**Preliminary review of
Recommendations for Enhancing Reactor Safety in the 21st Century: The Near-Term Task Force Review of Insights from the Fukushima Dai-ichi Accident,
U.S. Nuclear Regulatory Commission, July 12, 2011¹**

Arjun Makhijani, Ph.D.²
Prepared for Friends of the Earth
July 19, 2011

Figure 1: Map of estimated first year radiation dose, estimated by the U.S. Department of Energy.⁵

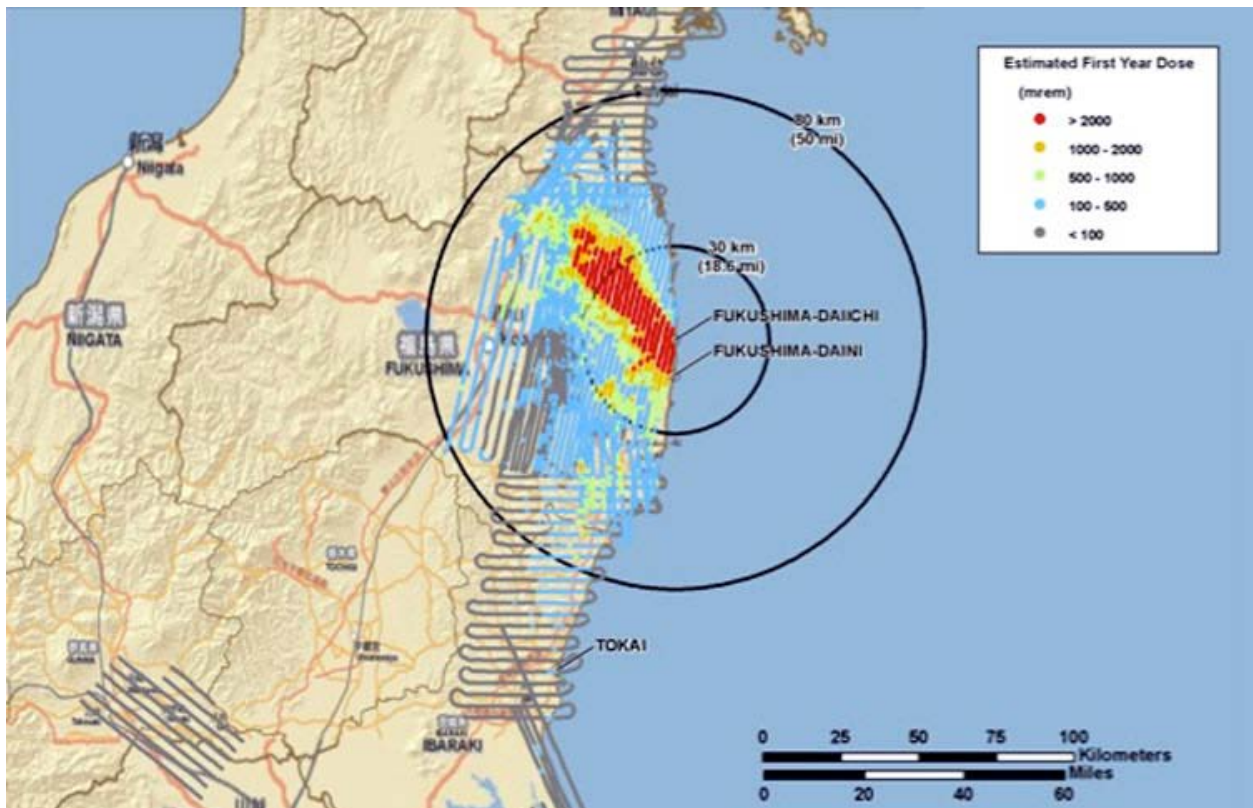
Figure 1 shows the radiation doses that the U.S. Department of Energy estimates will be experienced by the public around Fukushima in the first year after the accident from external radiation sources and inhalation of re-suspended particles if they stayed outdoors all the time. Building shielding factors, which would reduce dose, and internal radiation dose due to ingestion or incorporation of radioactivity via cuts and wounds, which would increase dose, are not taken into account. Ingestion of soil is especially important for children.⁴ Long-term risks will grow since there will be further radiation doses in future years and also from radioactivity deposited after the DOE surveys. Therefore, as a first approximation, the map may be taken as an order of magnitude indication of the risks faced by the public, especially beyond the 20-kilometer evacuation zone, where there were no restrictions on activities in the initial months.

The red-shaded area represents a dose of more than 2,000 millirem (2 rem). Using the cancer risk coefficient published by the U.S. EPA,⁶ the fatal cancer risk at the minimum dose of 2 rem would be about 1 in 1,150.

There are about 1.7 million people in the cities in the Fukushima prefecture. Many of these cities are within the 20-30 kilometer zone from which people were not evacuated but advised to stay indoors, and in the zone beyond that out to 70 or 80 kilometers, where there is contamination but no restrictions other than those on food. Almost 80,000 people in the 20-kilometer zone were evacuated, probably including thousands of children.⁷ There are more in the 20 to 30-kilometer zone where sheltering was recommended and even more in the contaminated area beyond 30 kilometers. It is unclear how many remained and for how long. But given the contamination and the fact that the doses will continue to accumulate after the first year – the half-life of the main long-lived contaminant, cesium-137 is about 30 years – there are likely to be many excess cancers in the high fallout areas. Thyroid diseases among children would be in addition to these problems, as would cancers among the many hundreds of workers who received doses of several rem up to the limit of 25 rem and sometimes above that limit.⁸ Internal doses will likely add to these totals. There would be one excess fatal cancer expected among every hundred workers who got 25 rem (or 1 among every 250 workers who got 10 rem). The occurrence of excess cancers would be about double the fatality rate. The Task Force provided no basis for its statement that there “the expectation of no significant radiological health effects.” At the very least it is premature. The available facts point in the contrary direction.⁹ Lack of adequate monitoring of the population and the low power of epidemiological studies may make it difficult to determine the actual outcome unless workers and the affected population have careful medical and radiological monitoring (for internal radionuclide deposition).

Had the Task Force considered children, the situation would look even worse. The fatal cancer risk for five-year-old female children is about 2.3 times that when the same dose is received gradually over a 70-year lifetime at all ages.¹⁰ This is because children in general and female children in particular are much more sensitive to radiation than adults.

Recommendation 1: The NRC should require a complete reevaluation of emergency planning zones, evacuation, and population protection in light of Fukushima, especially in densely populated areas where evacuation in zones extending out 30 or 40 miles will be essentially impossible and asking ten million or more people to stay indoors for extended periods of months is also equally impossible. While the report discusses the relative merits of evacuation versus sheltering, it seems disconnected from the reality of a form of radiation untouchability that emerged after the start of the accident; it consisted, in part, of fears of contact with people within the 20 to 30 kilometer sheltering zone around Fukushima who were thought to be contaminated. Many people outside that radius were extremely reluctant to enter the zone, while people in the zone were told not to go out. A similar phenomenon affected the survivors of the bombings of Hiroshima and Nagasaki. Is such a situation imaginable for the Bronx or Manhattan? The report does not say.
